**WASILLA PLANNING COMMISSION
RESOLUTION SERIAL NO. 20-13(AM)**

**A RESOLUTION OF THE WASILLA PLANNING COMMISSION APPROVING
CONDITIONAL USE PERMIT NO. 20-03 TO CONSTRUCT A 11,849 SQUARE FEET
AUTOMOTIVE REPAIR FACILITY, LOCATED ON LOT D10, TOWNSHIP 17 NORTH,
RANGE 1 WEST, SECTION 10 (GENERALLY LOCATED AT THE NORTHWEST
CORNER OF E. ROBERTS ROAD AND THE PALMER-WASILLA HIGHWAY).**

DATE: 10/20/2020
DRAWN BY: RL
CHECKED BY: RL
LANDSCAPE PLAN - WEST
SHEET 1
L103

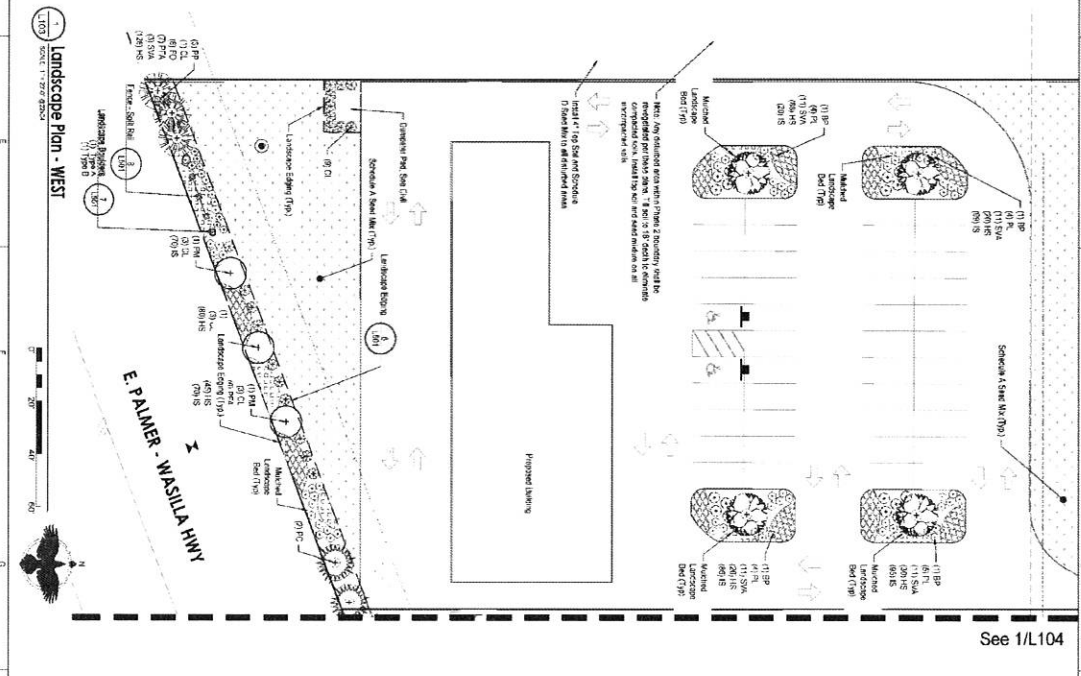
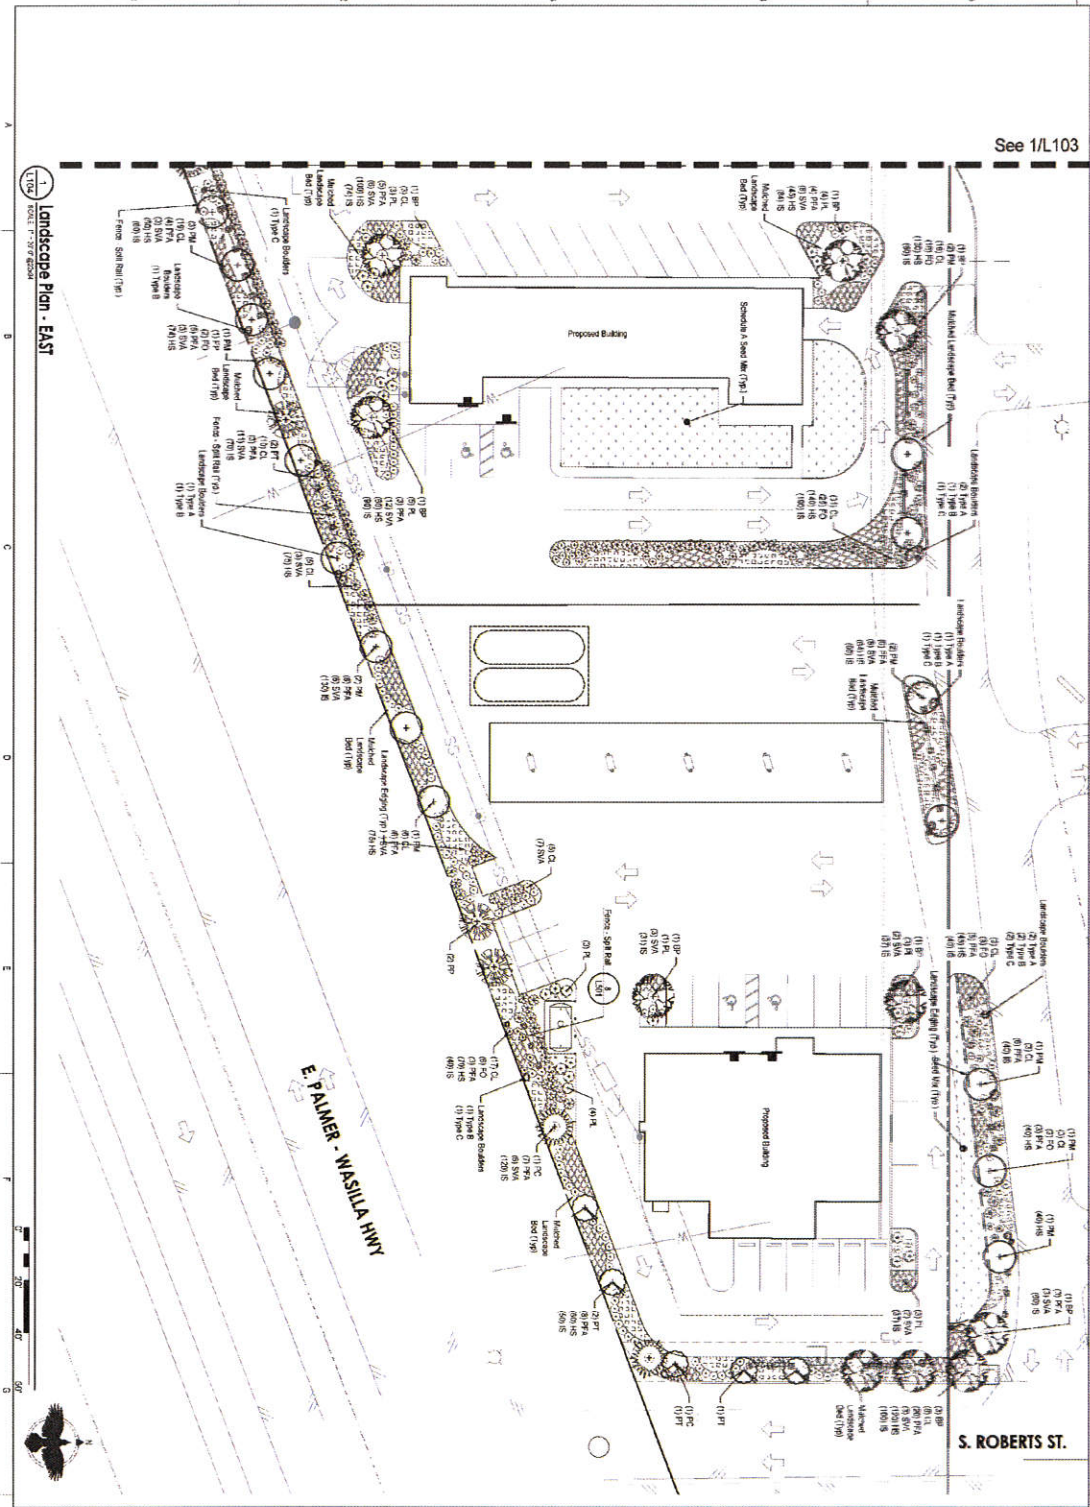
Finding: The landscape plan submitted with the application does not meet the landscaping requirements in Title 16. There are four issues that need to be addressed to be consistent with the landscaping regulations: (1) the applicant is proposing the use of rock mulch versus vegetative mulch; (2) the perimeter landscape bed along the Palmer-Wasilla Highway does not contain the required number or appropriate spacing of shrubs and flowers and needs at least one additional fencing panel; (3) the gates on the dumpster enclosure must be opaque; and (4) the proposed site plan and elevations do not adequately address the requirement to “break up” blank façades.

5. The applicant must submit a revised landscape plan that addresses the following:
 - (1) Revise landscape beds to indicate the use of vegetative mulch.

- (2) Add required number of shrubs and flowers with appropriate spacing and add one additional decorative fence panel in the perimeter landscape bed along the Palmer-Wasilla Highway.

- (3) Revise the dumpster design to include opaque gates.
 - (4) Provide elevations and/or landscape plan that meet the requirements in WMC 16.33.060(F) to "break up" blank façades.

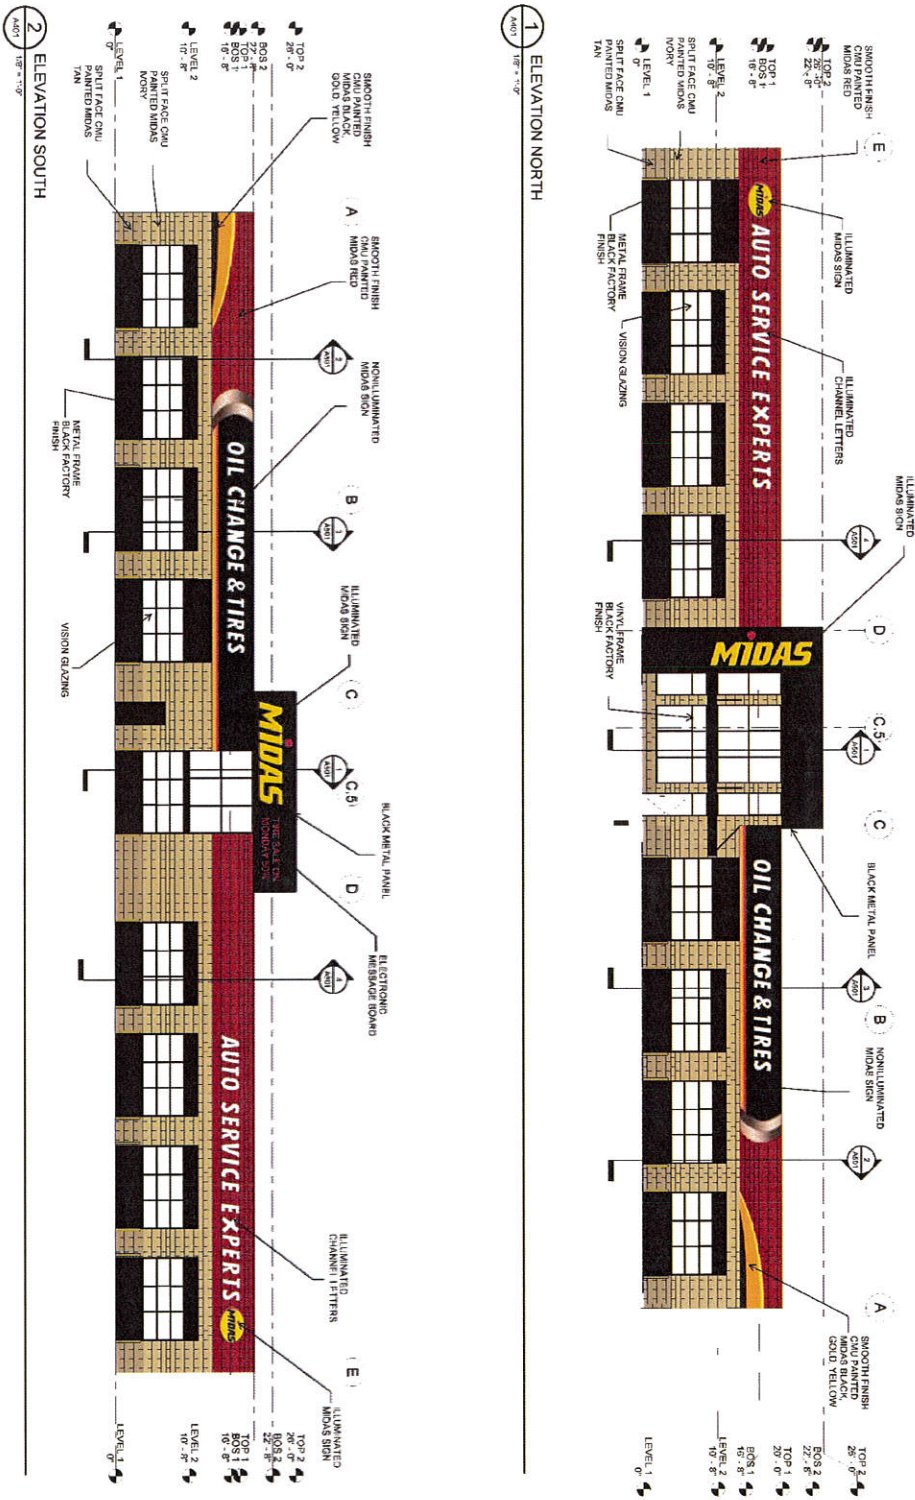
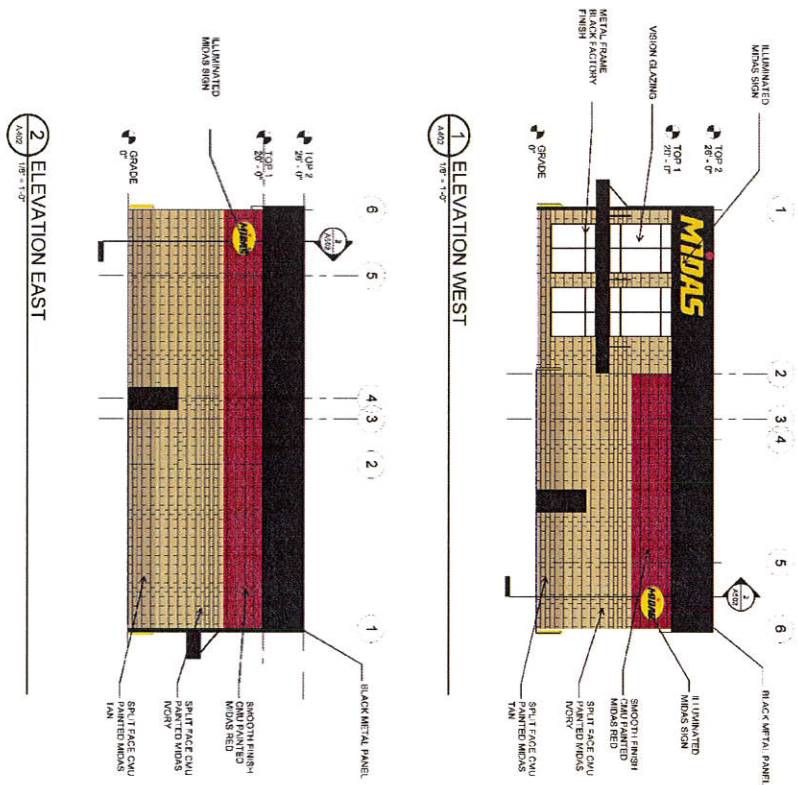
Finding: The appearance is more industrial in appearance than the nearby commercial uses. Staff is proposing a condition of approval to require the applicant to submit revised elevations that incorporate more of the architectural and features proposed for the north side of the building (awning, paint, façade projections, etc.) on the south side of the building (facing Palmer-Wasilla Highway).
